Title: ERID-111328 SUBMITTAL OF THE RESPONSE TO THE NOTICE OF DISAPPROVAL FOR THE INVESTIGATION WORK PLAN FOR LOWER PAJARITO CANYON AGGREGATE AREA AND REVISION 1, INCLUDING 2 CD'S, EP2010-0521, EP2010-0522, LA-UR-10-7635

To:(Addressees - Organization) JAMES BEARZI, NMED

From:(Senders - Organization) MICHAEL J GRAHAM, LANL
 GEORGE J RAE, DOE

Figure 4.11-1 Site features of SWMU 18-003(g), SWMU 18-003(h), and AOC 18-012(c)

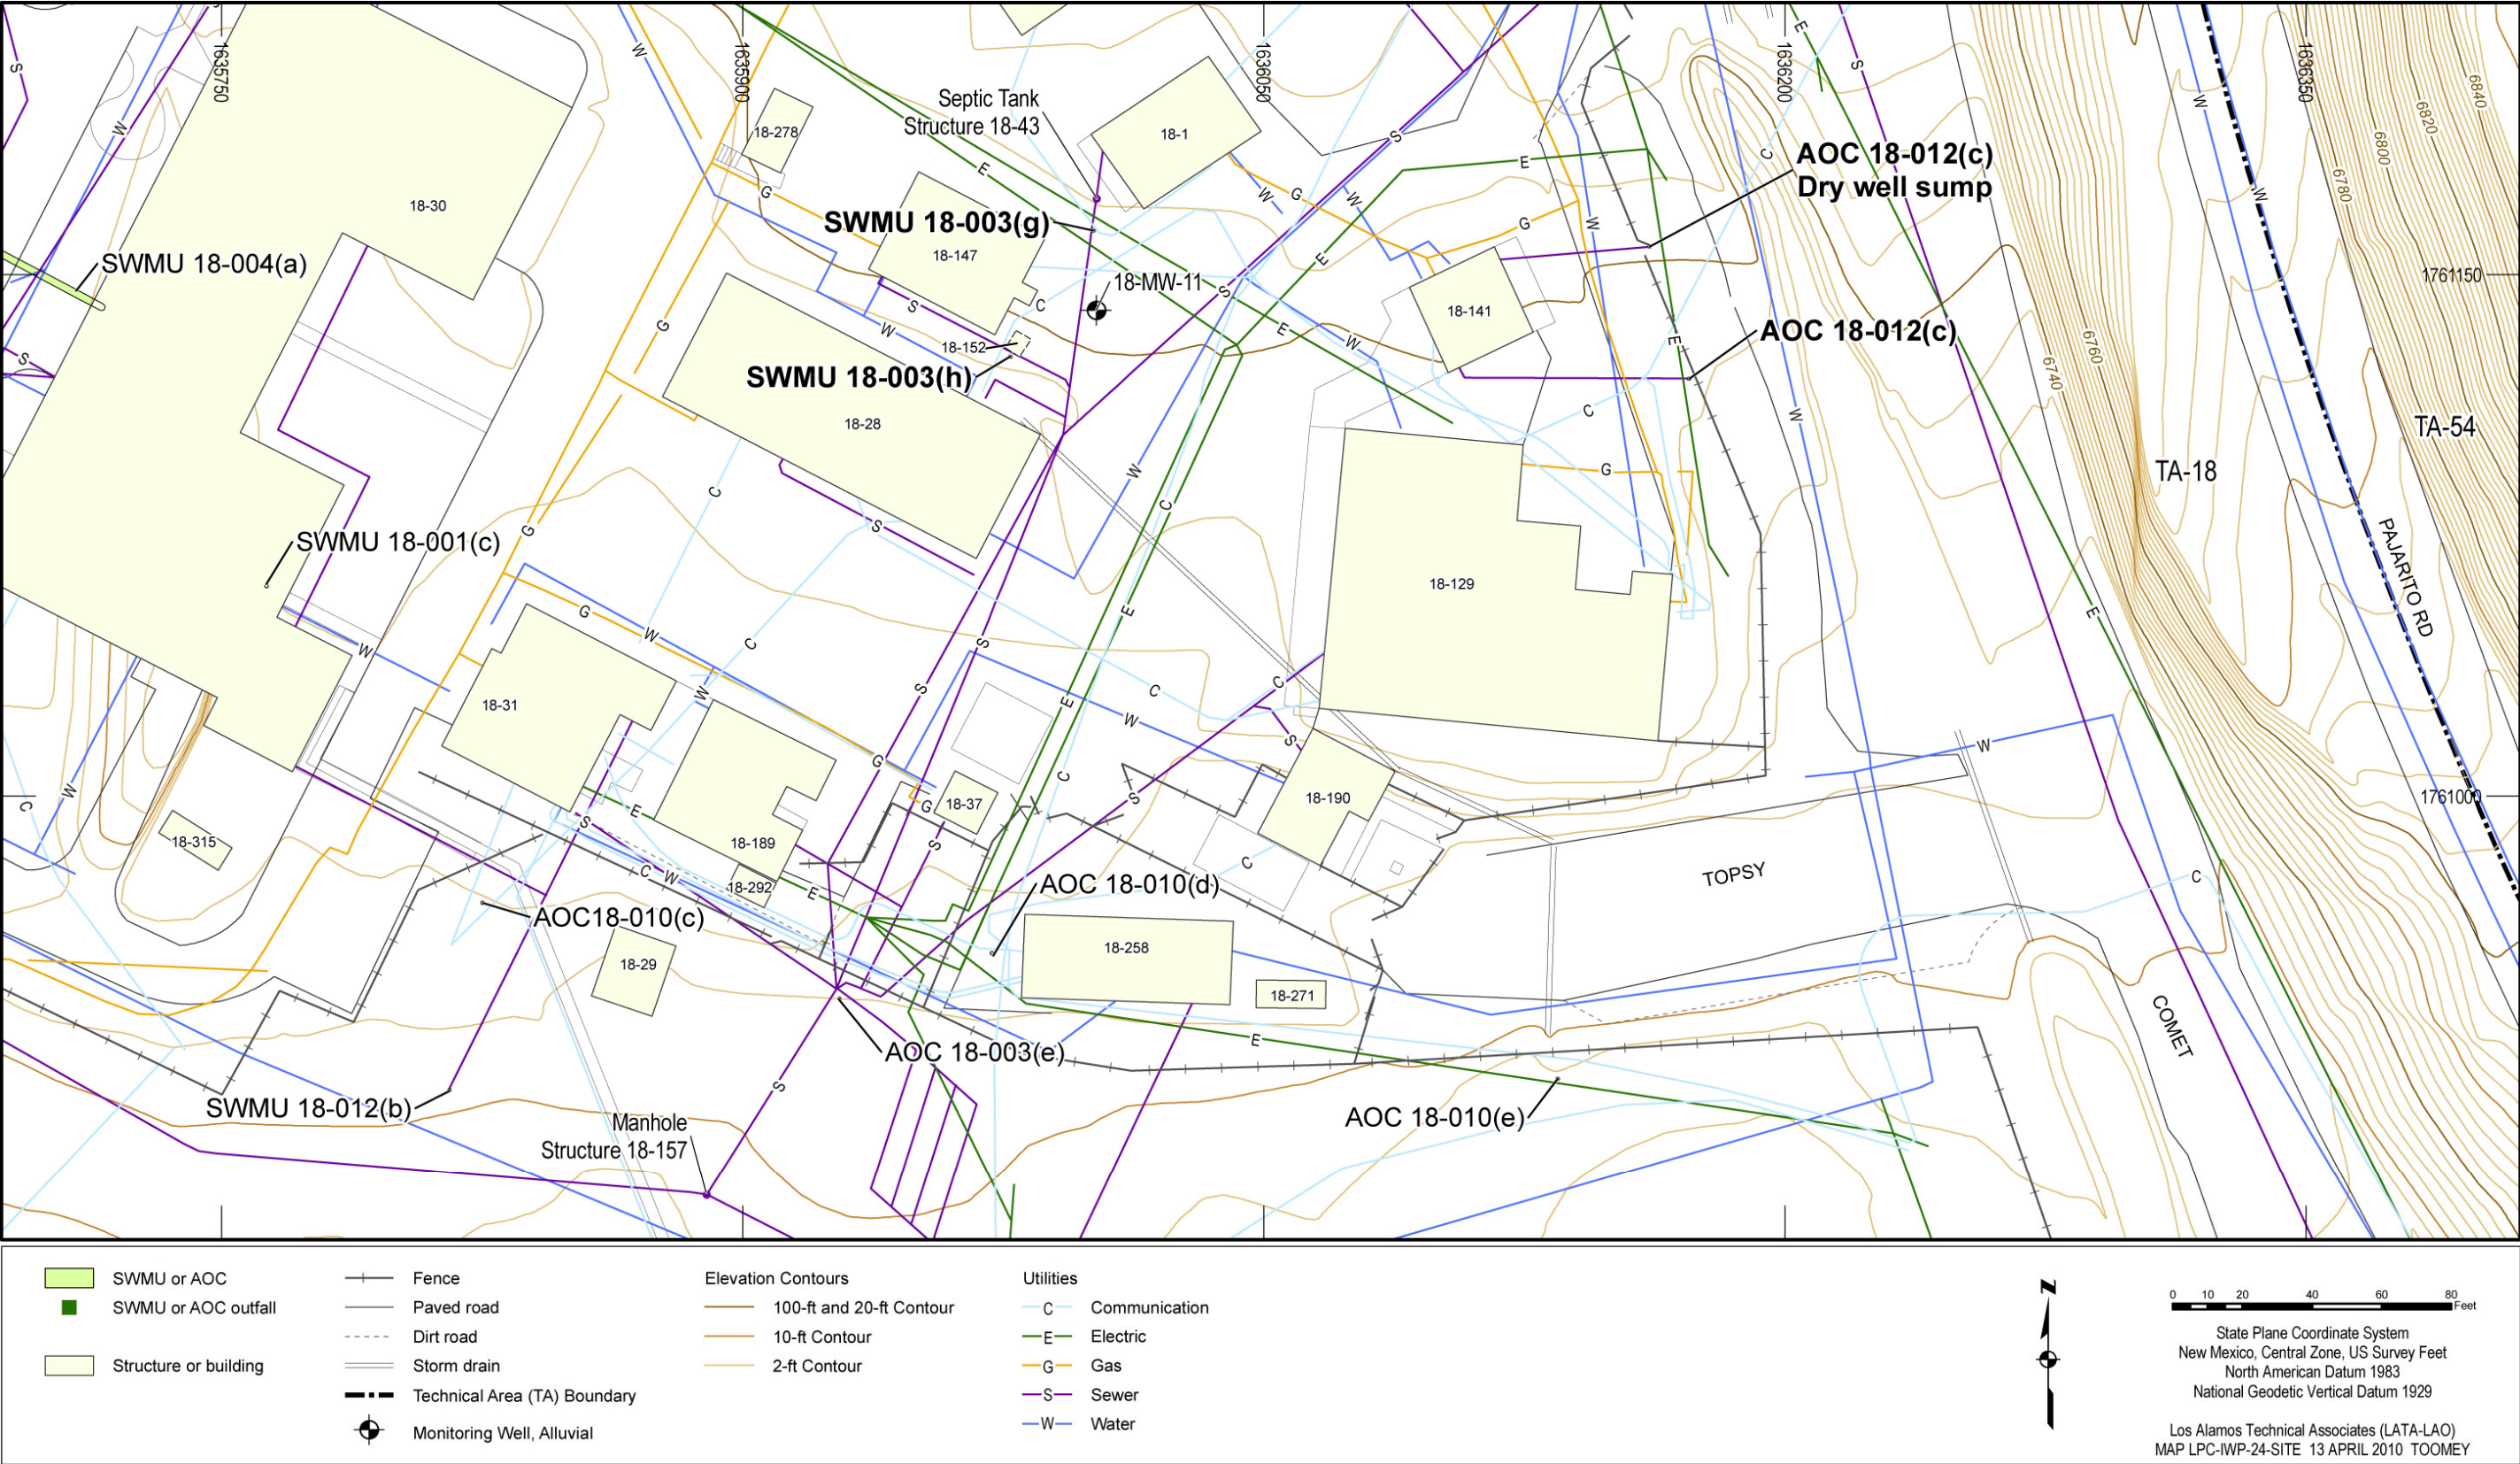
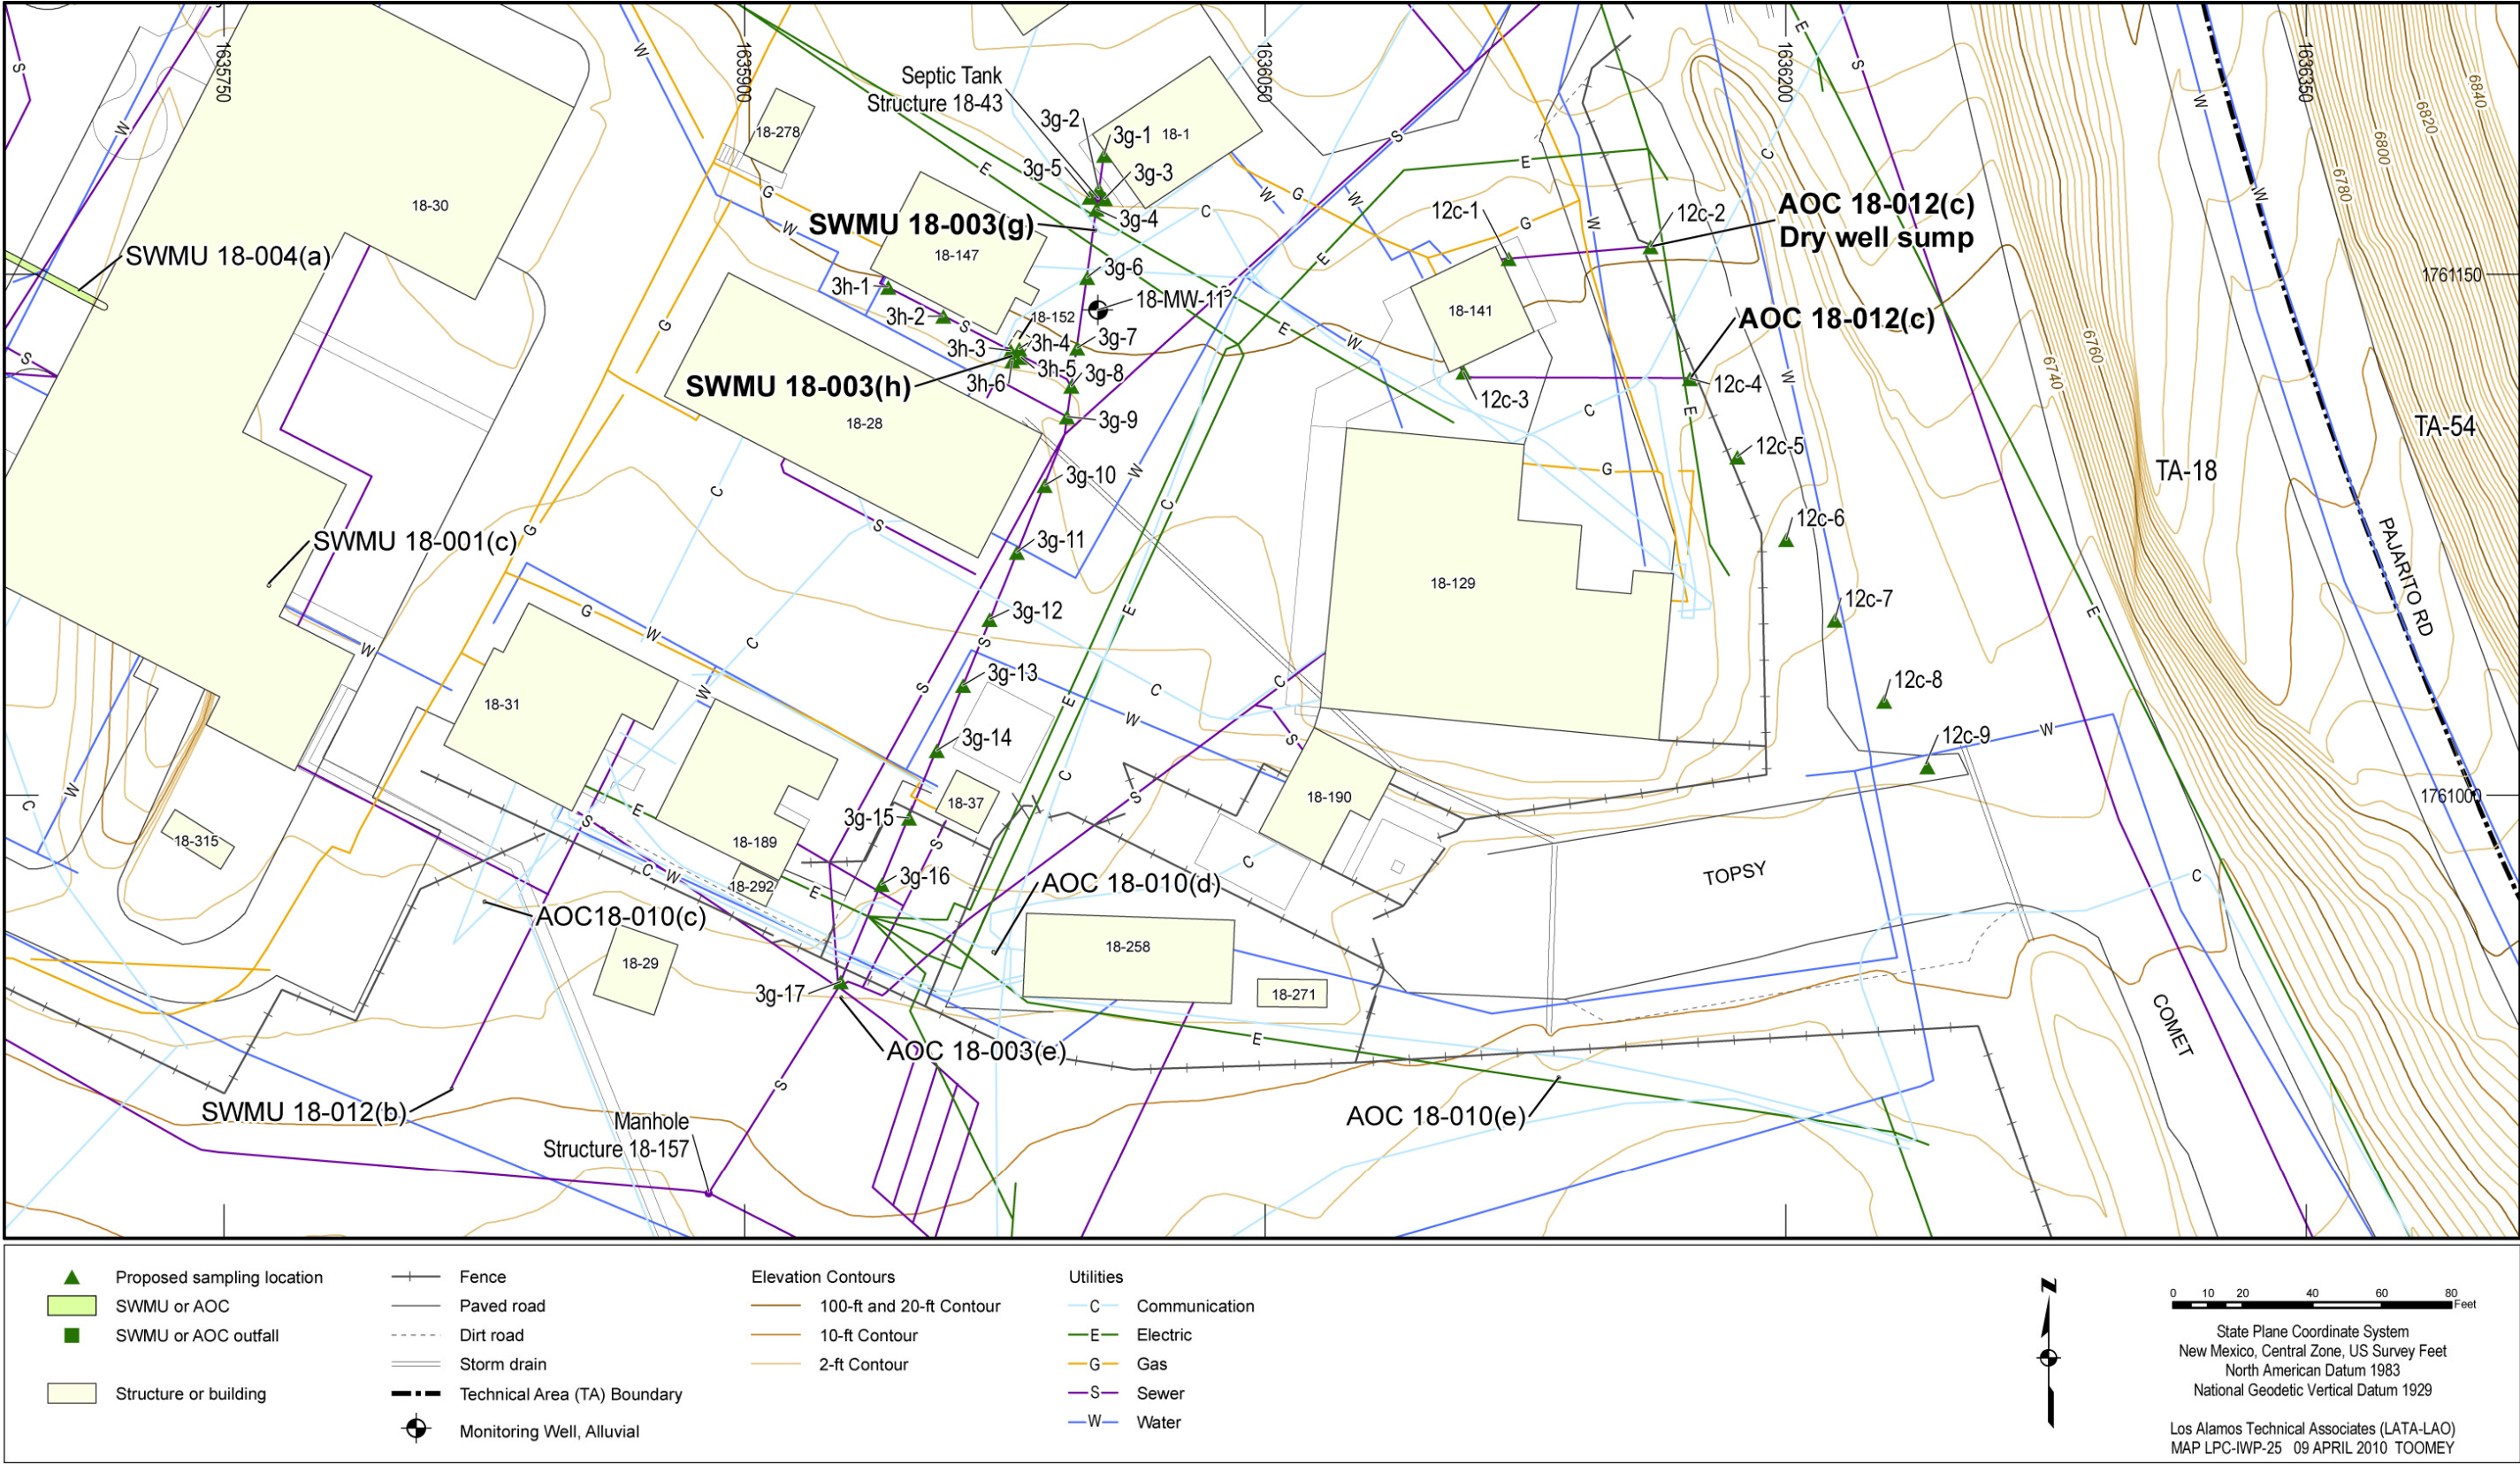
NMED Comment: Confirm that well M-11 is the same as well 18-MW-11 shown on Plan Plate 1 and, if confirmed, show the well location on all figures associated with the SWMU. Indicate that if the well is sampled in 2011, the groundwater monitoring data will be included in the IR.

21. The reference to well M-11 in section 4.11.1 of the text has been changed to well 18-MW-11, the current Laboratory designation for the well. Figures 4.11-1 and 4.11-2 have been revised to indicate well 18-MW-11.

- 34. Section 4.24.3, Scope of Activities for AOC 18-012(c), first paragraph, first and second lines, third paragraph, first and second lines and Figure 4.11-2, Proposed sampling locations for SWMU 18-003(g), SWMU 18-003(h), and AOC 18-012(c) and Table 4.24-1, page 174:**

beneath the lines. Correct or add to the sample intervals as needed for the evaluation and revise the table to match the text statements. Provide the proposed sample interval information for the 12 samples that will be collected in the vicinity of the outfall location. In addition, the southern-most drain line appears to be mislabeled as “AOC 12-012(c)” on Figure 4.11-2; review and revise the figure as needed for clarity.

The label on Figure 4.11-2 has been corrected from “AOC 12-012(c)” to “AOC 18-012(c).”
